**Cogentrix Quail Brush Generation Project - Docket Number 11-AFC-3, Responses to CEC Traffic Questions (March 13, 2012 Technical Conference Call)**

Subject: Response to Questions on Quail Brush Traffic Study

**APPLICATION FOR CERTIFICATION  
FOR THE *QUAIL BRUSH GENERATION PROJECT***

**Figure A**  
**Construction Traffic Distribution - Employee Traffic**

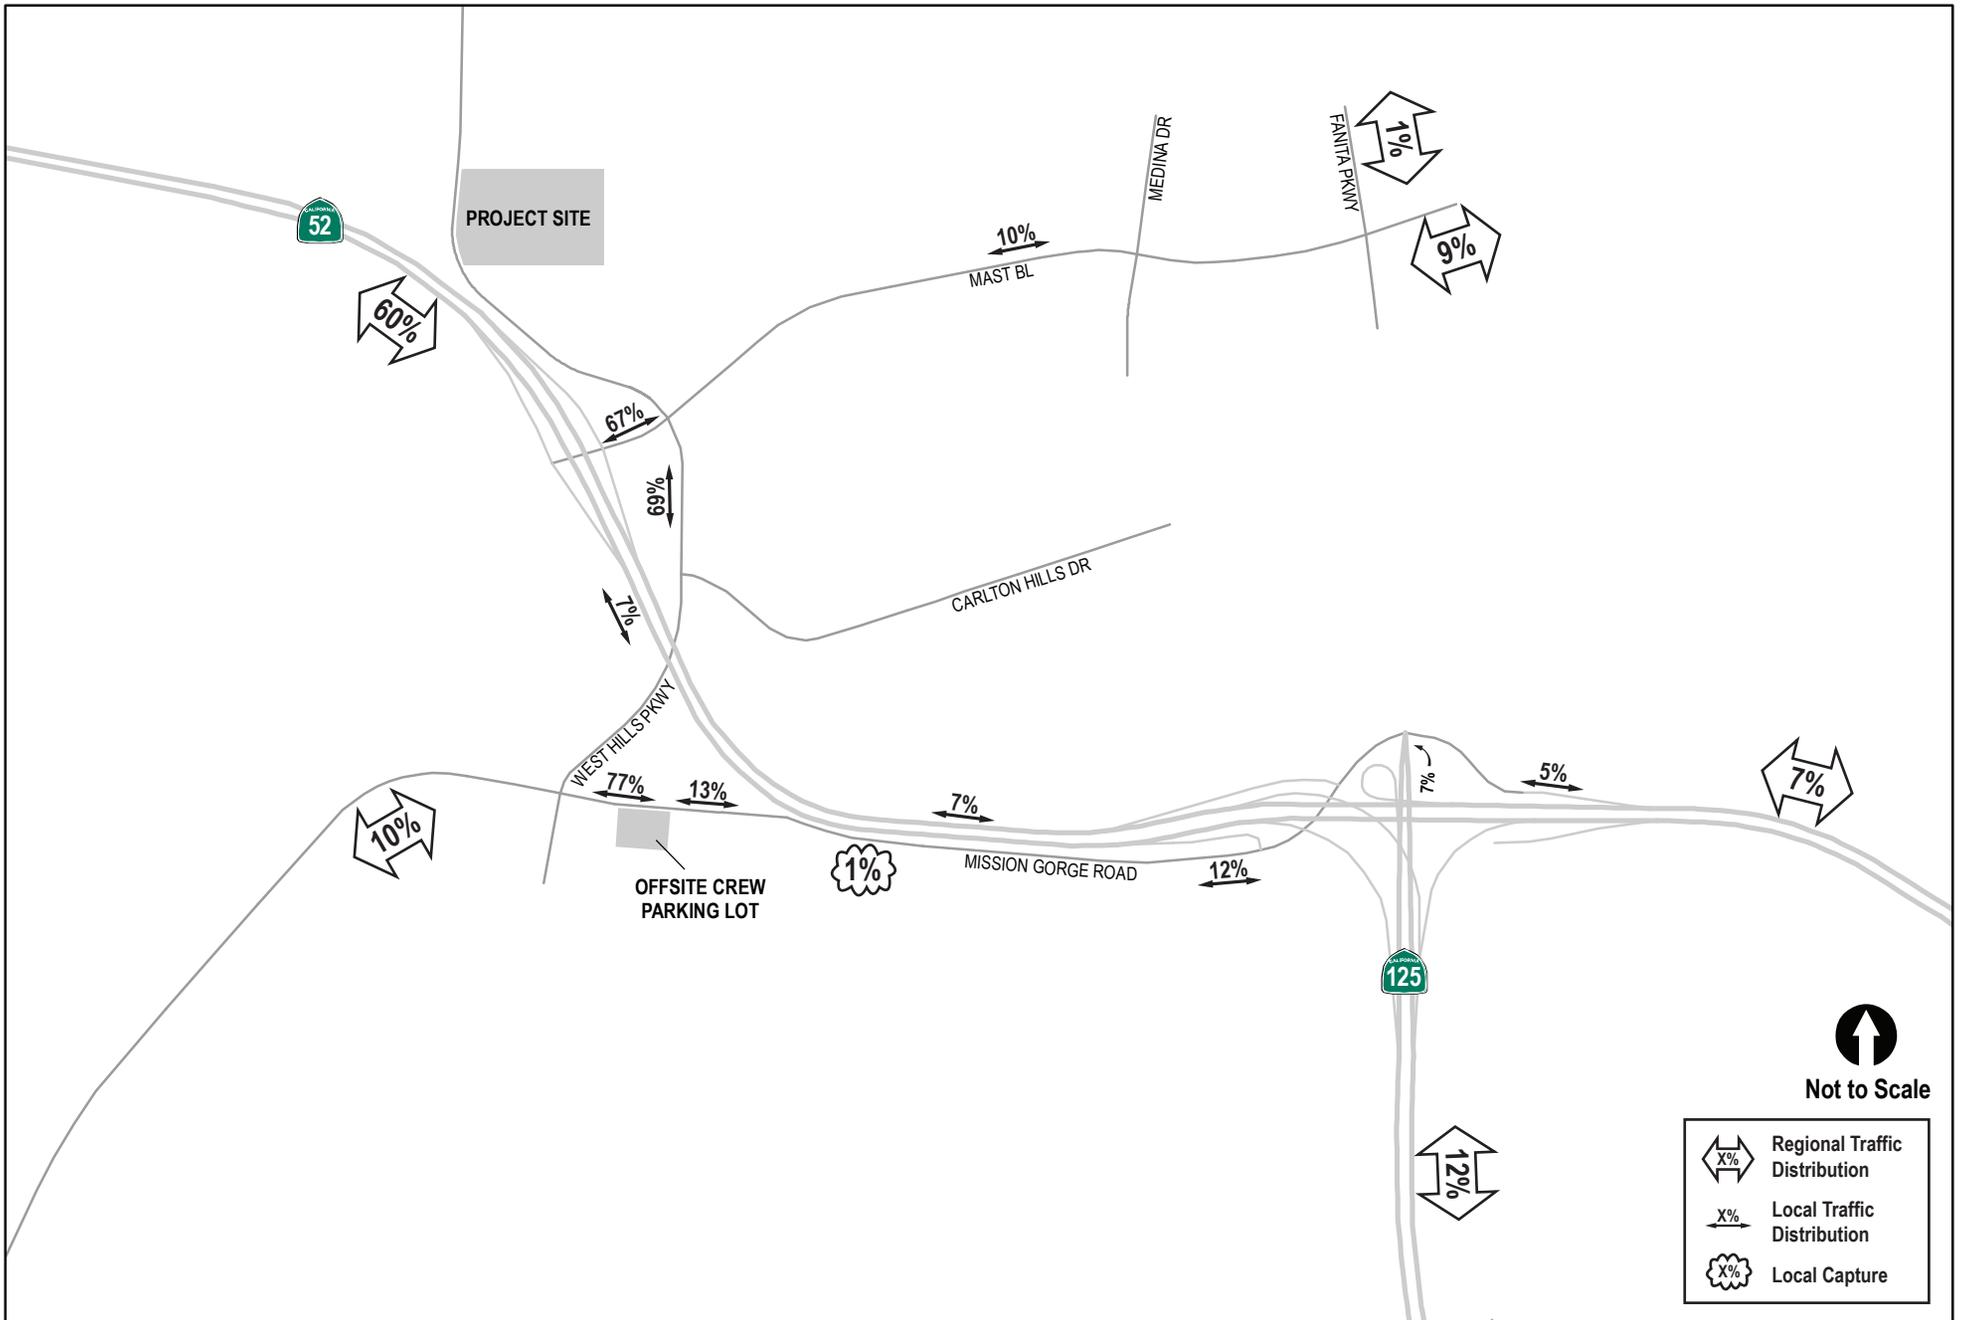
Q1. Mission Gorge Road should be analyzed if project traffic is expected to utilize the roadway.

**In the traffic study, the 7% is the percentage on SR 52 between SR 125 and Mast Boulevard. A percentage is not shown on Mission Gorge Road. *Figure A* (attached) shows the forecasted construction worker distribution percentages on Mission Gorge Road. The travel time from SR 125 to the offsite crew parking lot is similar for the (1) SR 52 to Mast Boulevard to West Hills Parkway route versus the (2) Mission Gorge Road route so it was deemed proper to assume a small portion of crew members would use the SR 52 route.**

**Overall, 77% of construction workers were assumed to approach the offsite lot from the west and 13% from the east. (The other 10% were assumed to park on-site).**
